**Instruction No. K14
Proposed Public Housing Redevelopment
at Pak Tin Estate (Phase 12)
Environmental Assessment Study (EAS)**

Draft Final Report (Revision 1)

Proposed Public Housing Redevelopment at Pak Tin Estate (Phase 12)
Environmental Assessment Study (EAS) EPD's comment regarding submission of the captioned EAS report (September 2023)

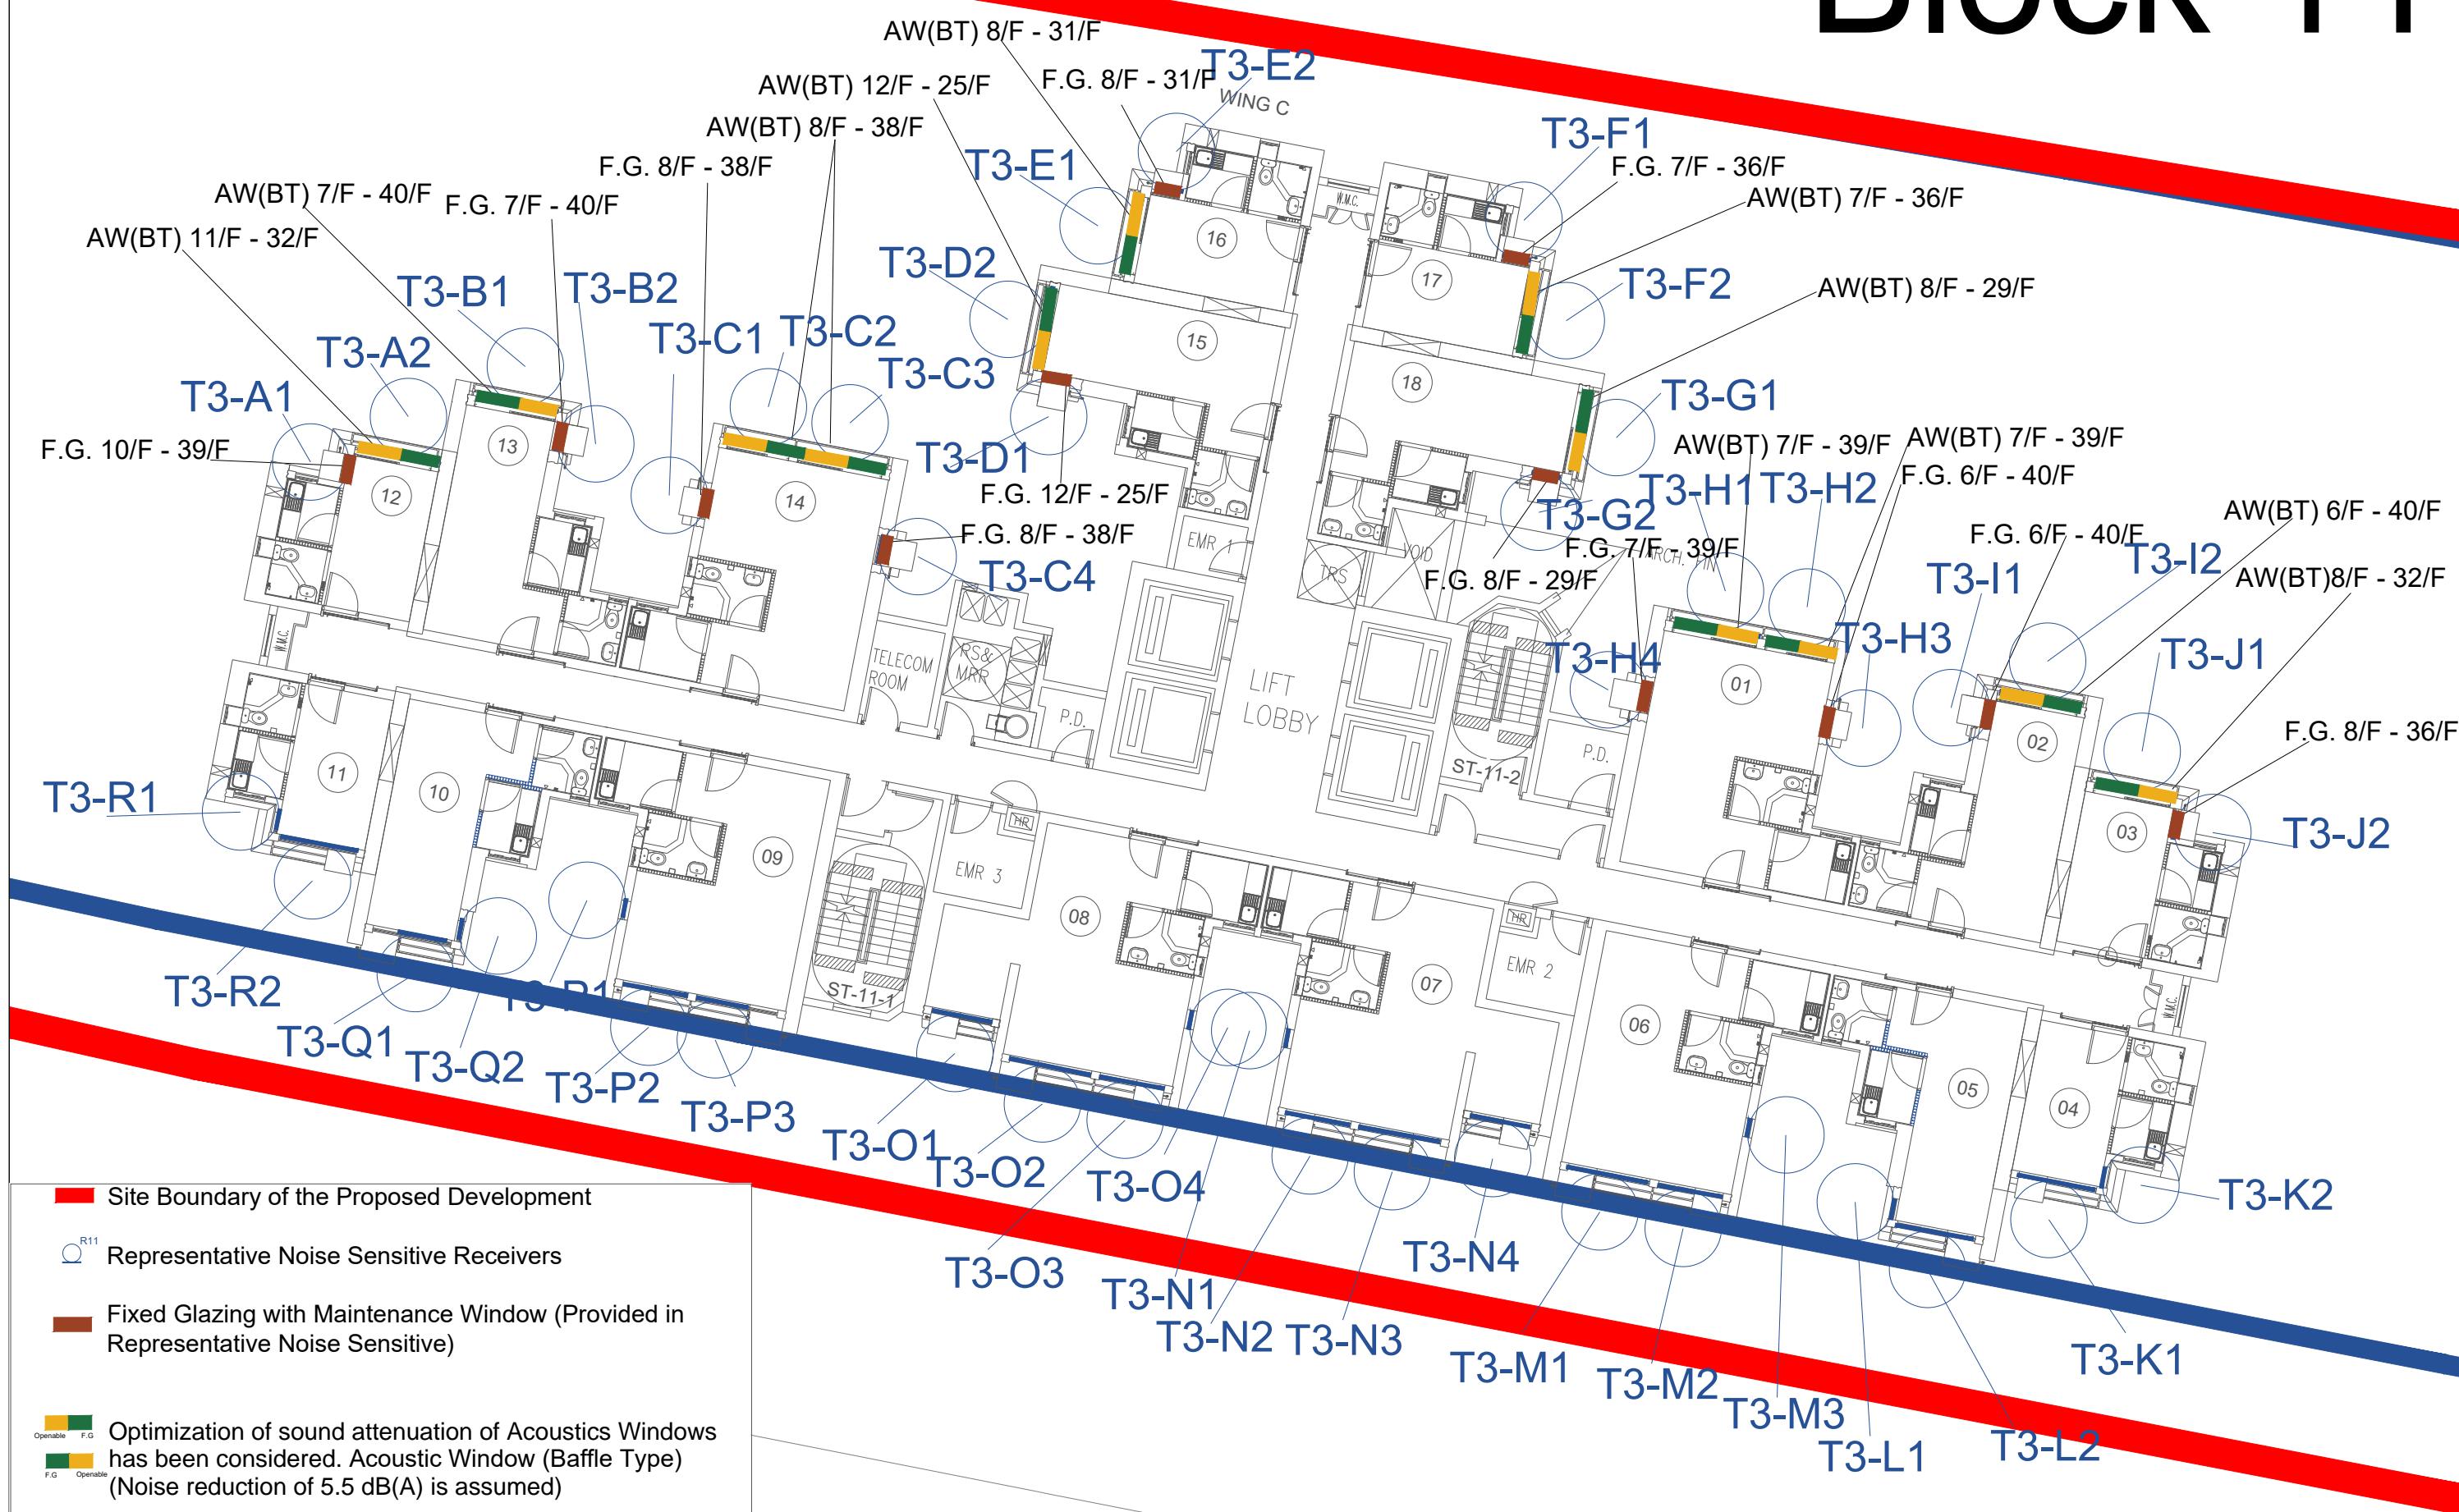
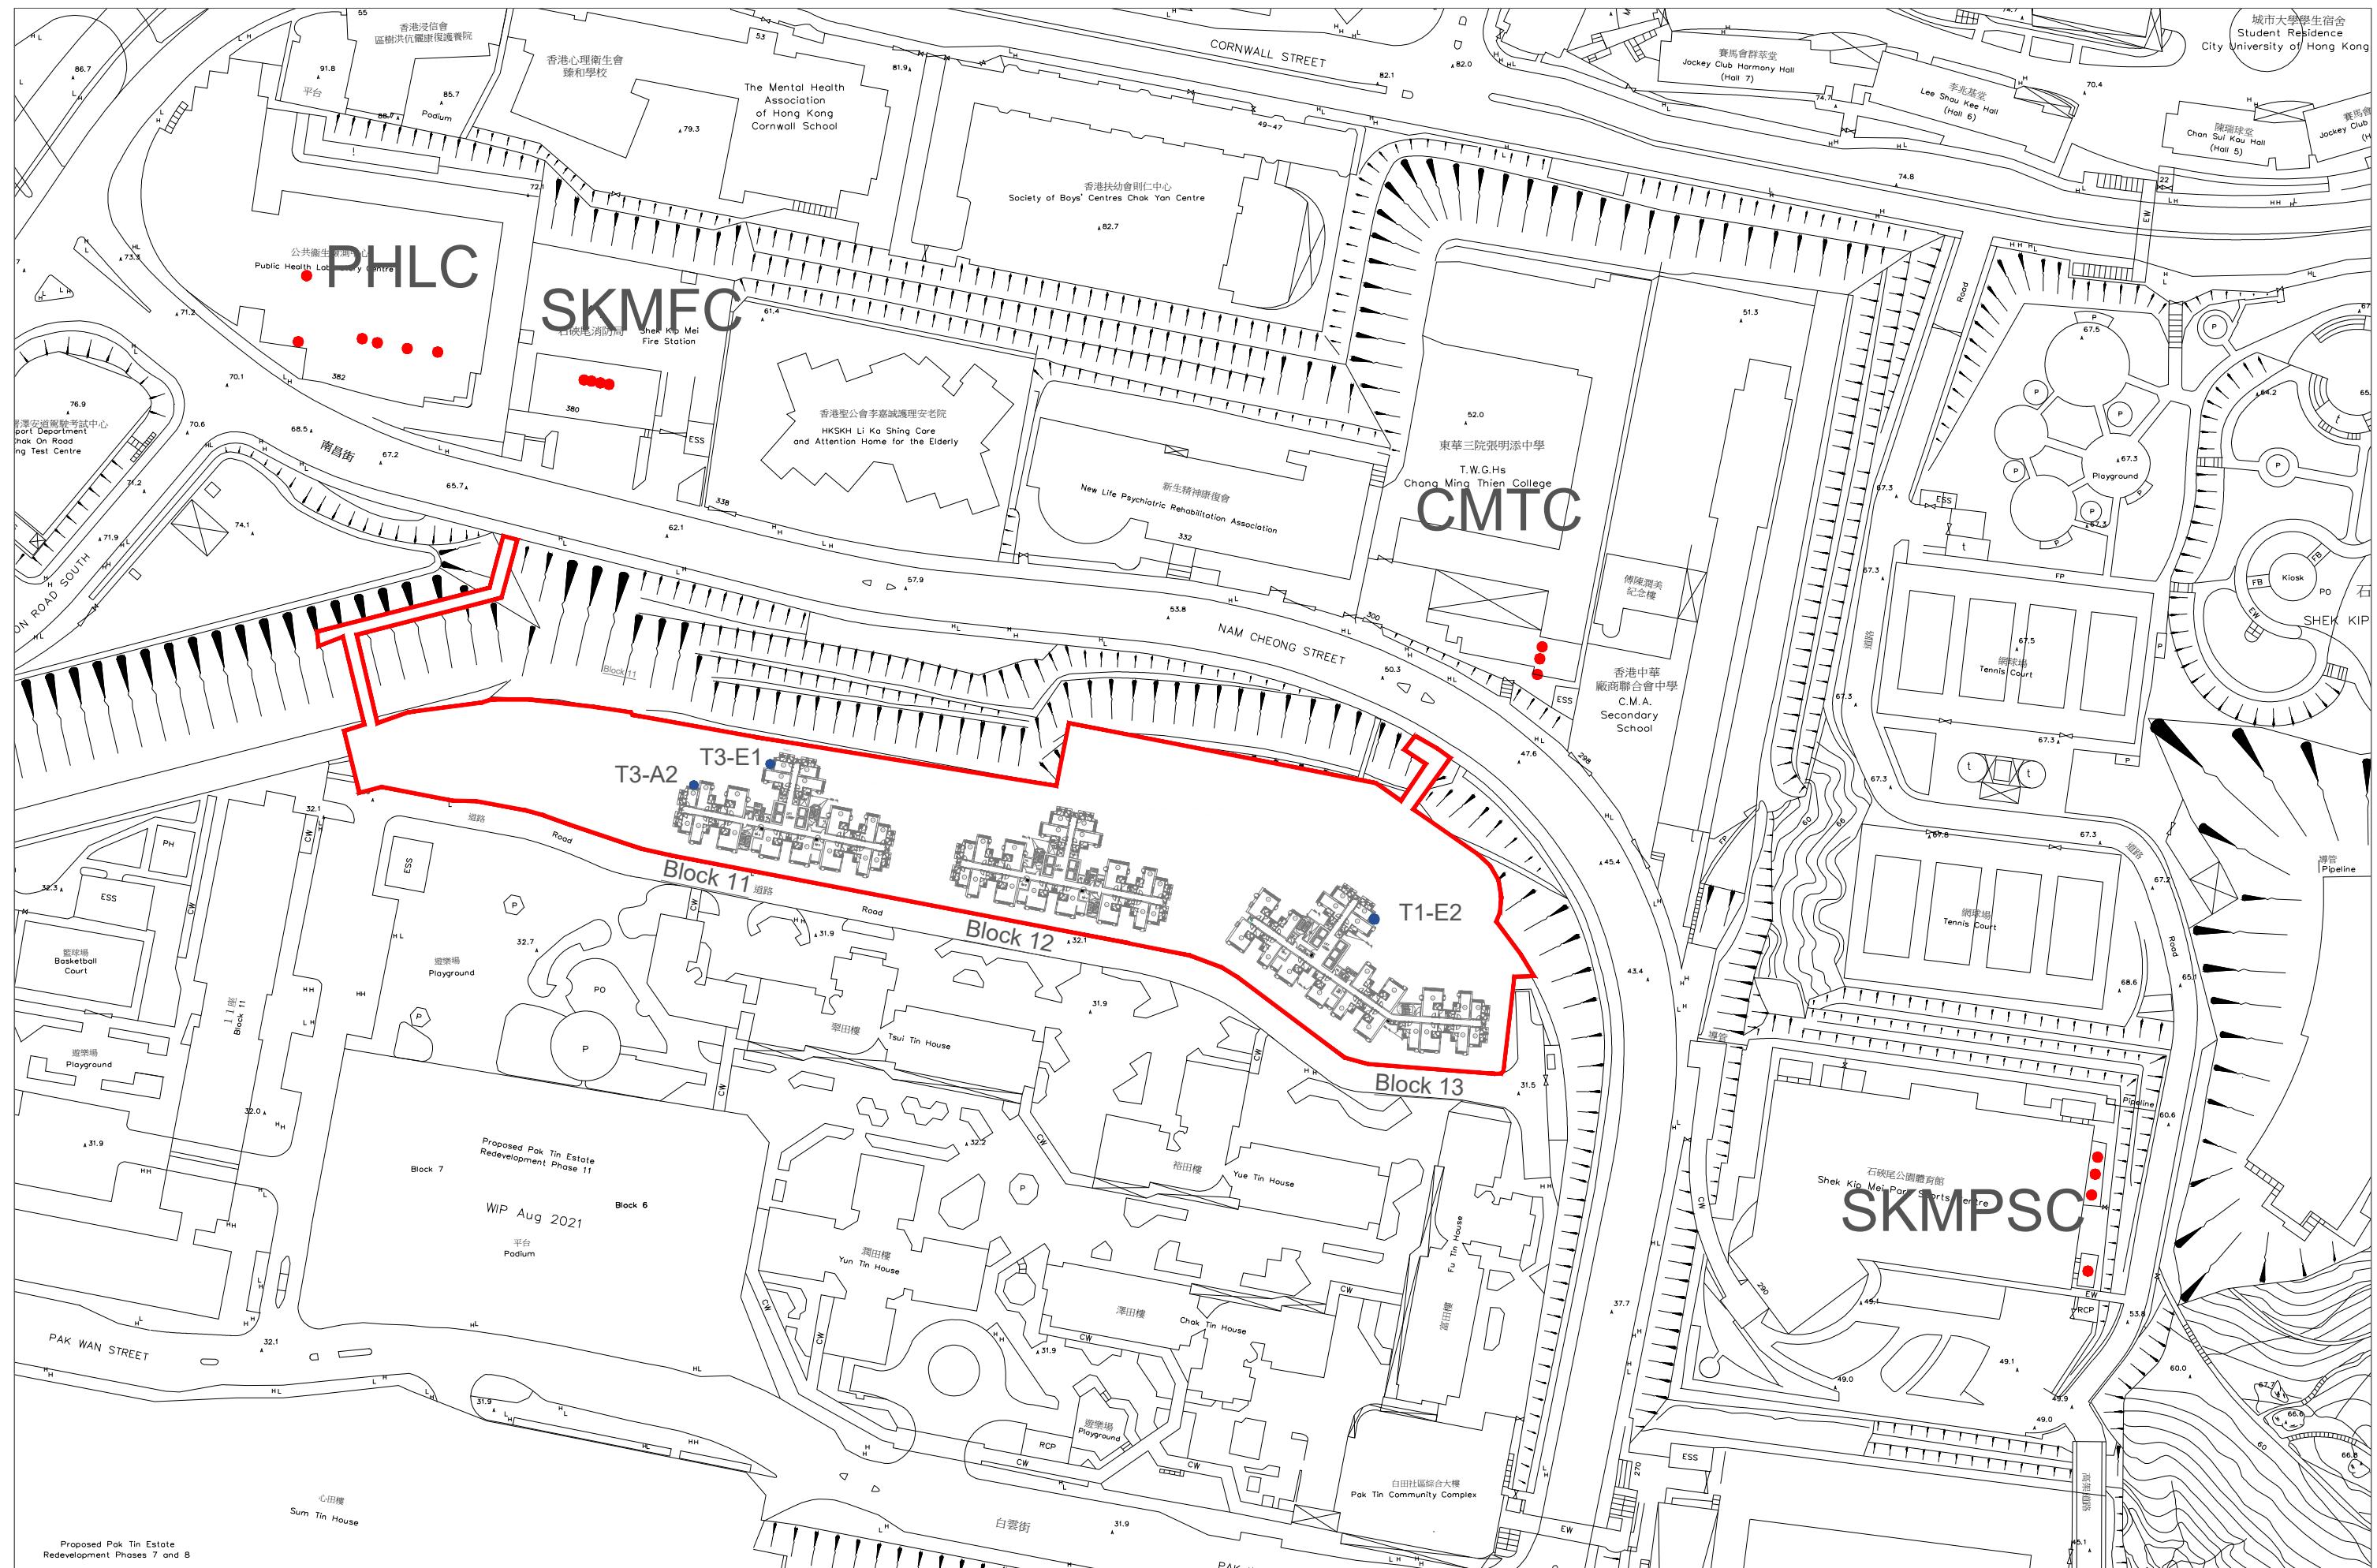
5.	Section 2.4.7 - The word "Flat" should read "Flat". Please check.	Text revised.
6.	Section 2.4.17 -	
	(a) Both window settings are proposed and indicated on Figures 2.5, 2.6 and 2.7. Please check if the settings are indicated	Figures 2.5, 2.6 and 2.7 are updated.
